## *Mask Set Errata 1*

# **MC68HC12D60 Microcontroller Unit**

This errata provides mask-set specific information applicable to the following MC68HC12D60 MCU mask set devices:

- 0K13J

Figure 2. Representation of unreliable start-up mode with slow crystal

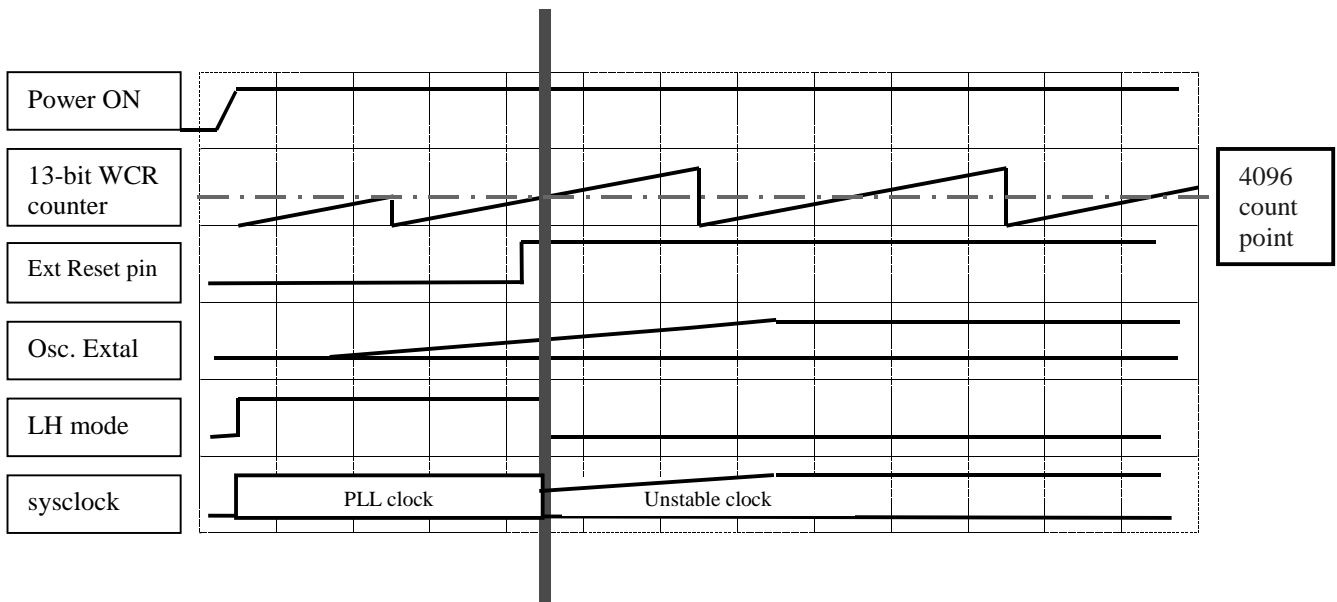
The HC12 mode of operation known as Limp-Home Mode (LHM) is enabled when the VDDPLL pin is at VDD and is entered if for any reason the external crystal ceases to oscillate. During this mode the CPU will be clocked from the free-running VCO clock of the PLL (at a nominal frequency of 1MHz). If LHM is enabled during the start-up phase (i.e. VDDPLL=5V, NOLHM bit=0) and the external RESET line is not held active until after the crystal frequency is stable then the device starts up in LHM since no crystal oscillations will be detected. This situation can arise with short reset periods and/or crystals that exhibit slow start-up characteristics.

For the first 4096 cycles i.e. during the internal reset period, Limp Home mode will be de-asserted if oscillator activity is detected by the clock monitor circuit -due to the asserted Reset signal there can be no CPU activity during the Reset phase. Following release of the external or internal POR RESET in LHM (which ever is later) the crystal oscillator is sampled by the clock monitor circuit after another 4096 VCO clock cycles and at intervals of 8192 clock cycles thereafter until the crystal is deemed to be operating. If the crystal oscillator is showing activity at the time it is checked then it will be deemed to be good, even though it may not have fully stabilized, and LHM will be de-asserted. This can cause the device to switch from LH mode to normal mode with the CPU clocked from an unstable signal from the crystal oscillator (see fig. 2) resulting in unpredictable function of the CPU.

Figure 3. Representation of preferred means of overcoming issue with Figure 2

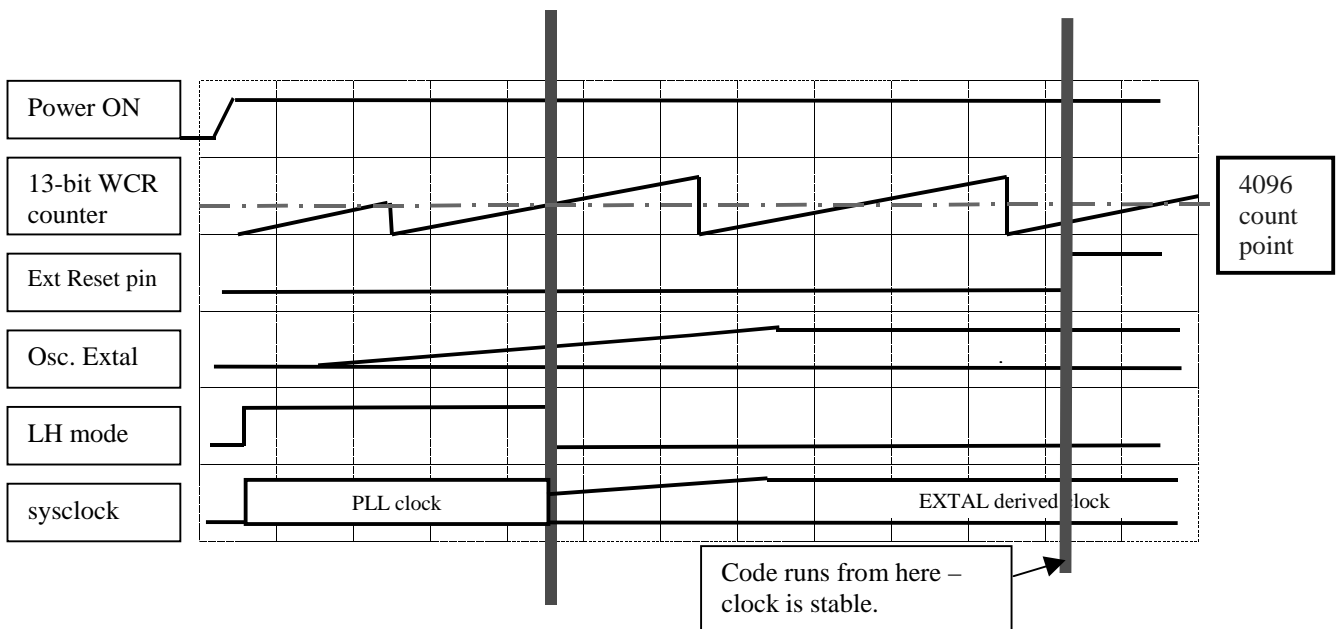
The Reset condition can be overcome by allowing the crystal oscillator circuit to stabilize before releasing the external RESET line (see fig. 3). Operation is similar to that shown in fig 2.

Lastly, an alternative and simpler approach is to just hold reset low for a substantial time (> 100 milliseconds) after Vdd has reached the operating voltage range.
